## ADDENDUM NO. 1

Issue Date: March 27, 2025

Project Name: Van Buren Public Schools  
RAHS Belleville High School  
West Columbia Avenue  
Belleville, Michigan

IDS Project No.: 24167-1000

E4.2

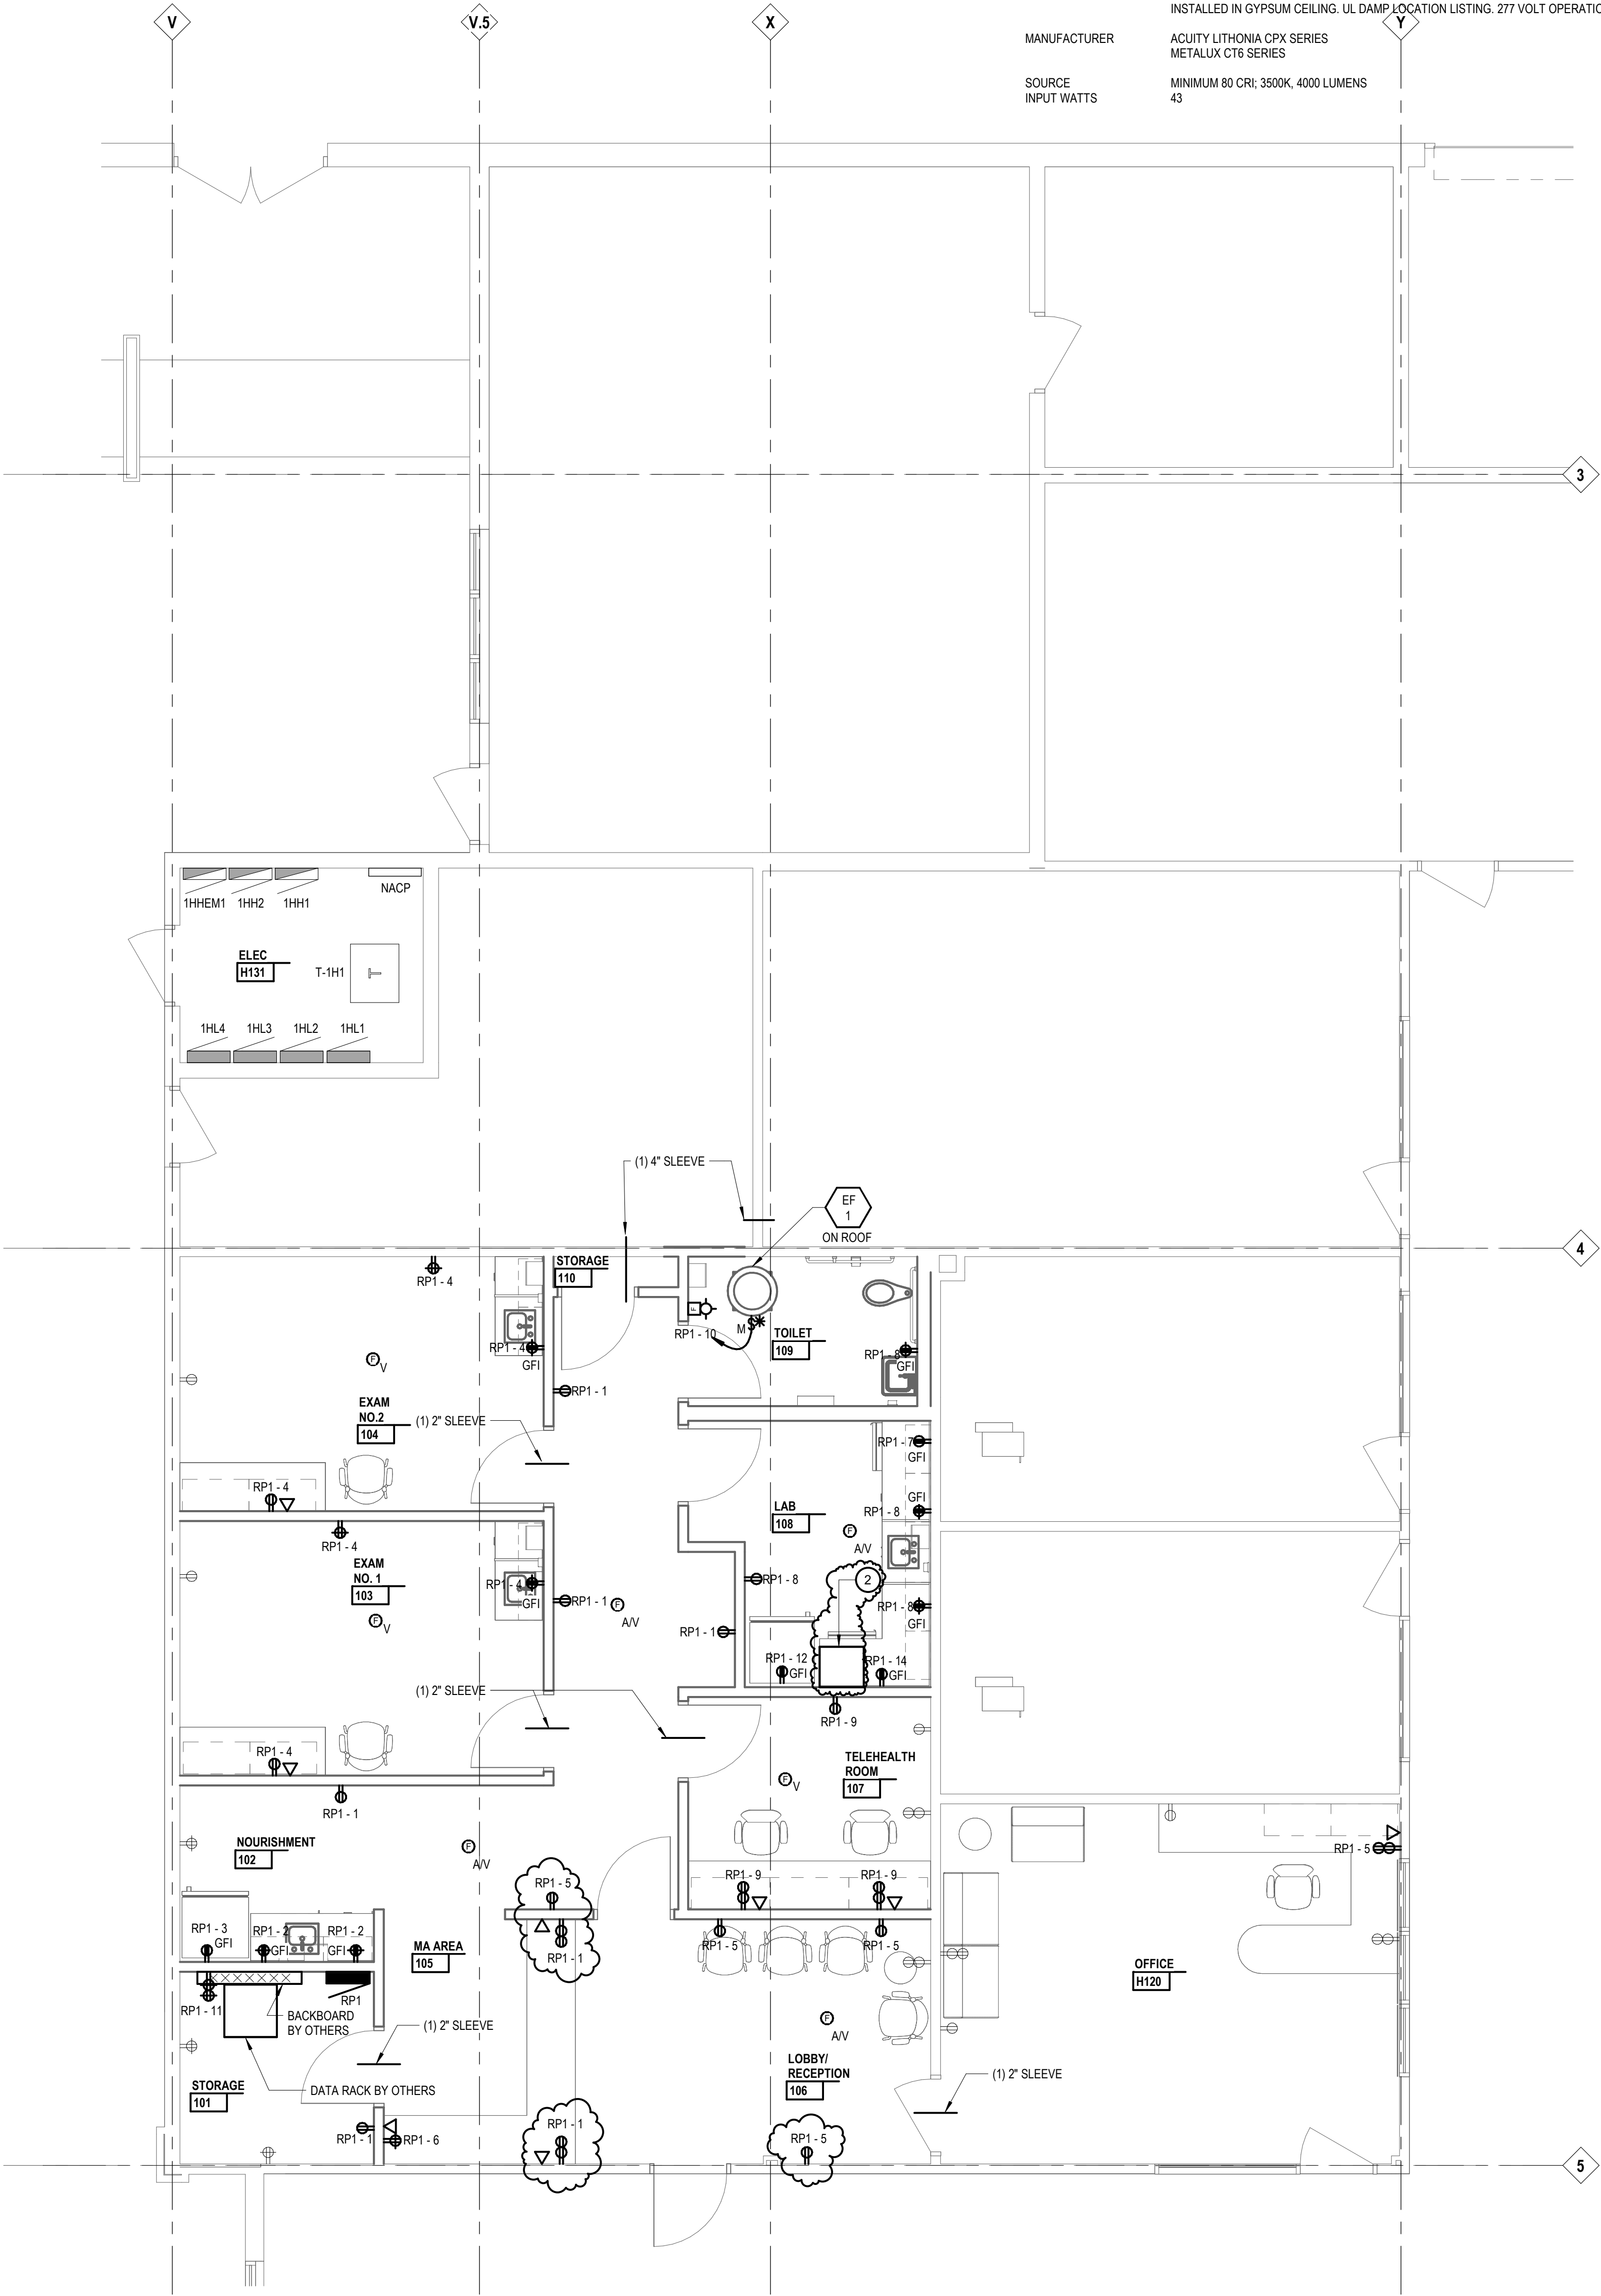
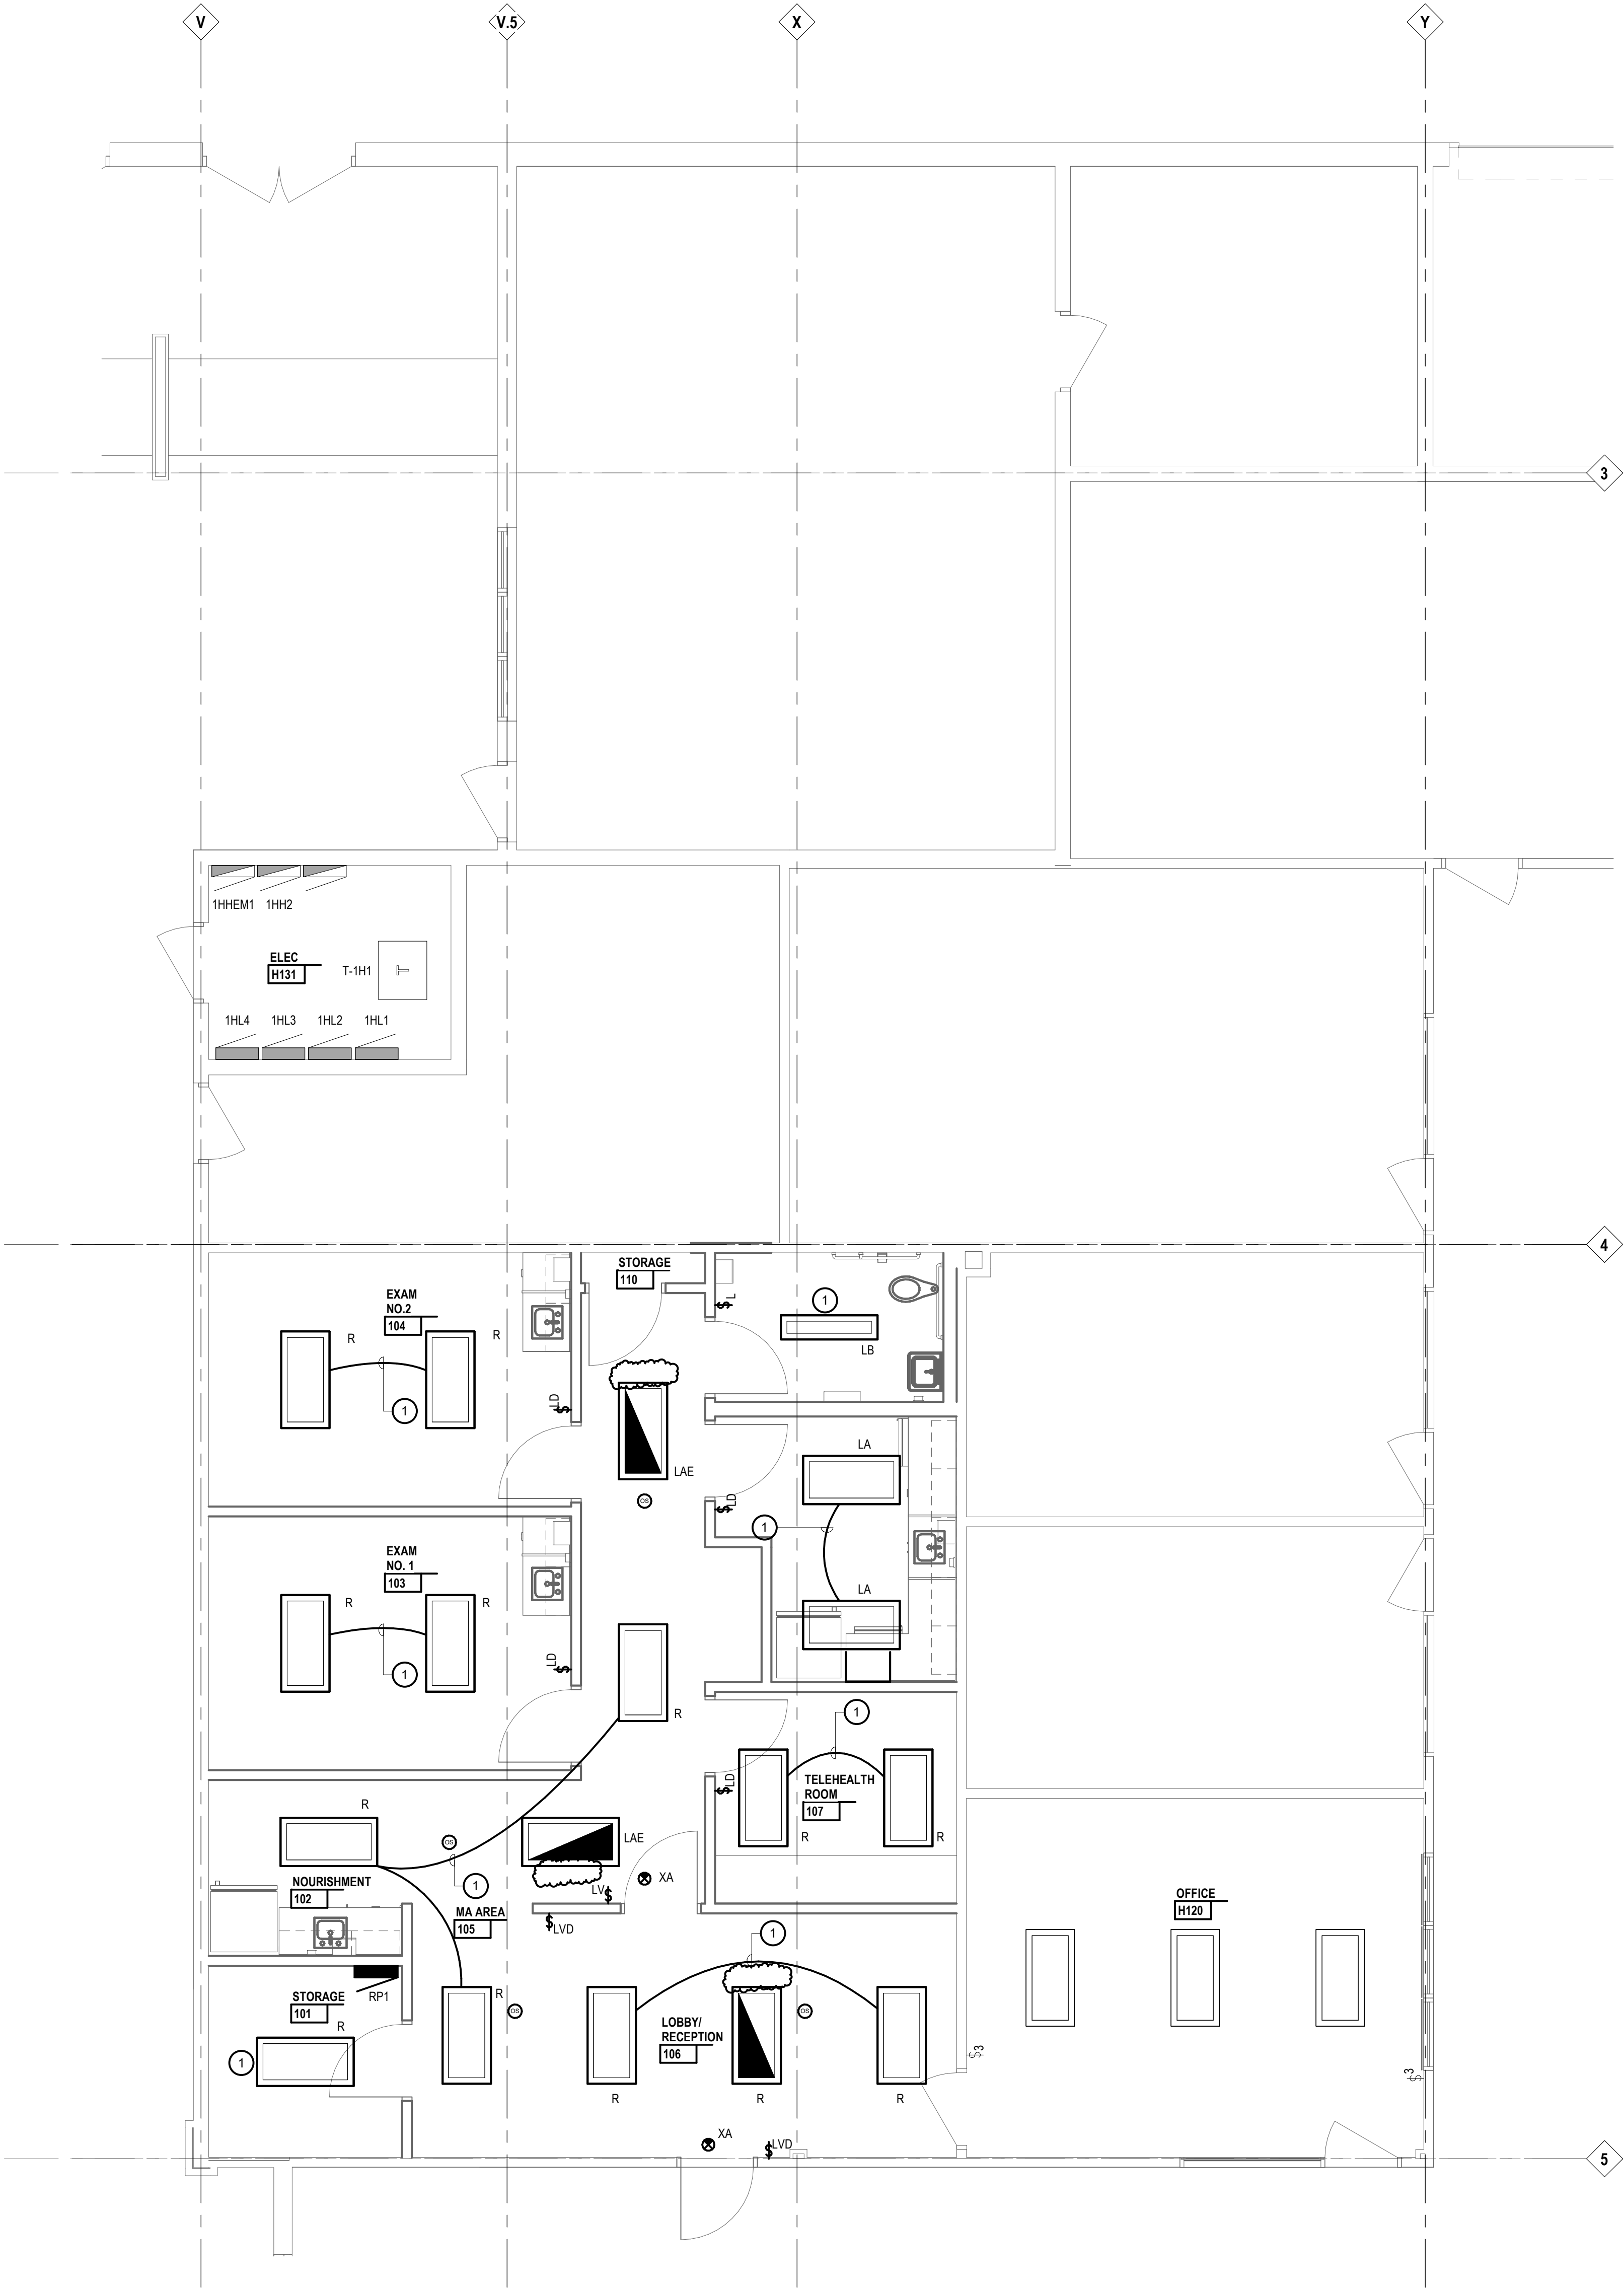
- 1
- EXTEND EXISTING LIGHTING BRANCH CIRCUIT LOCATED IN CEILING SPACE.
- 2
- PROVIDE AND INSTALL BACKUP POWER SUPPLY FOR UNDERCOUNTER REFRIGERATOR EMERGENCY POWER. MANUFACTURER: XANTREX. MODEL NO. POWERHUB 1800 (PH-1800-GFP), PLUG UNIT INTO DUPLEX RECEPTACLE. CIRCUIT NUMBER: RP1-12. PLUG UNDERCOUNTER REFRIGERATOR INTO THE BACKUP POWER SUPPLY.
